Memorandum

Subject: Draft Santana Ranch Drainage System Interim Improvement Peer Review

HDR | WRECO has reviewed the Swale Sizing Calculations for the Santana Ranch Development Project (Project) Drainage System performed by O'Dell Engineering (12/1/2021) and Drainage Improvement Plans (12/1/2021). These Improvement Plans are provided in response to the recommendations provided by HDR | WRECO (11/29/2021). The following summarizes our findings and recommendations in order of priority to reduce flooding along Fairview Road and the properties to the north of the Project.

Figure 1. Drainage Areas for Interim Drainage Improvements

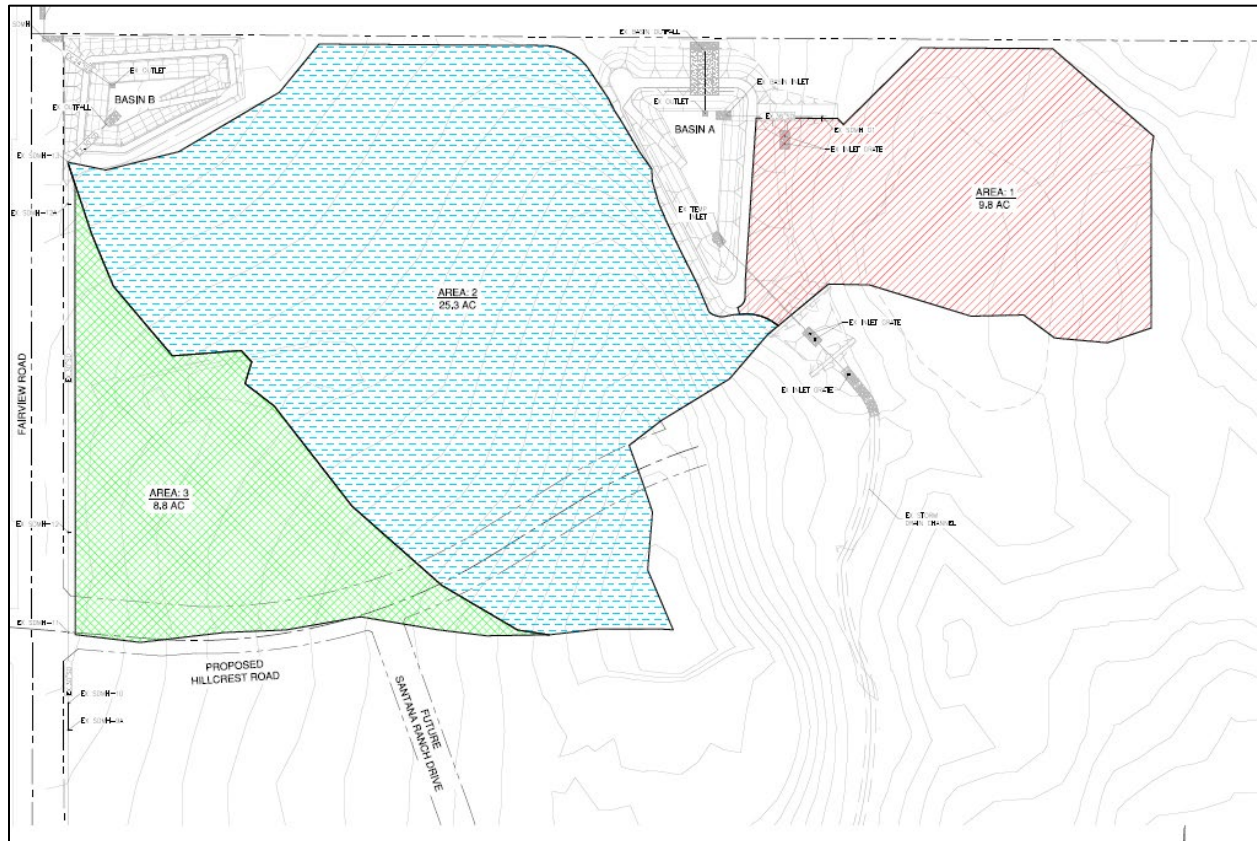
The interim drainage improvements focus on three drainage areas that are portions of phase 9 and phase 11 of the development located at the northern most section of the site. The boundaries provided appear to be consistent with the available topography and capture the most likely sources of water that drain to the north and to Fairview Road (see Figure 1). There is an area east of Basin A that is not accounted for however, topography indicates this area should discharge east of the affected property.

Figure 2. Cross Section of Swale and Berm Structure

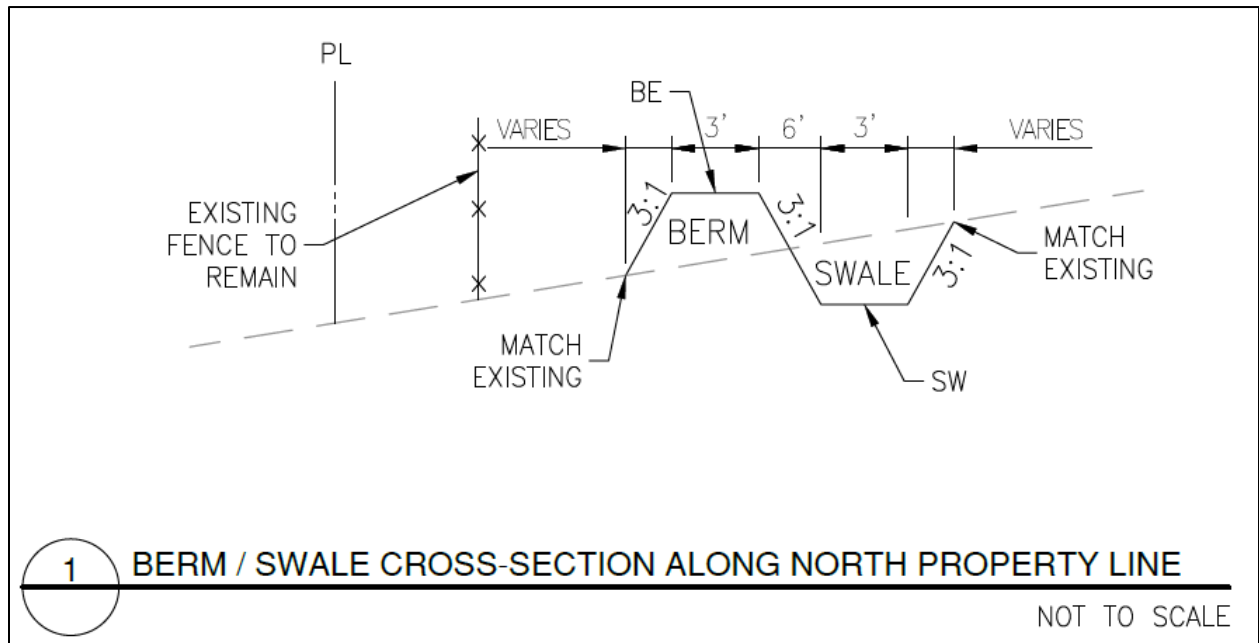
The interim drainage improvements include a parallel swale and berm to bound portions of the undeveloped site on the north and west sides of the property. The berm is on the offsite side with the swale on the onsite side (see cross section in Figure 2).

The swale calculations use a Manning's *n* roughness coefficient of 0.03. This value is sufficient as long as the swales are maintained and kept free of debris and weedy growth. The grading plan calls out berm top elevations that in some locations appear to be at or below grade as well as some swale location that appear to be at or above grade. It should be confirmed that at all

locations the berm is higher than the existing grade and the swale is lower than the existing grade to ensure runoff is contained and routed to the basin. The berm is adjacent to the swale and the elevation should be higher than the existing grade on the onsite side of the swale to provide protection from overtopping due to possible restrictions/ponding at the basin inlet. Finally, there is an option of increasing berm elevation near the basin inlet to provide additional storage at the basin inlet and additional protection from restrictions/ponding at the basin inlet. See Figure 3 for a plan mark-up of these comments.
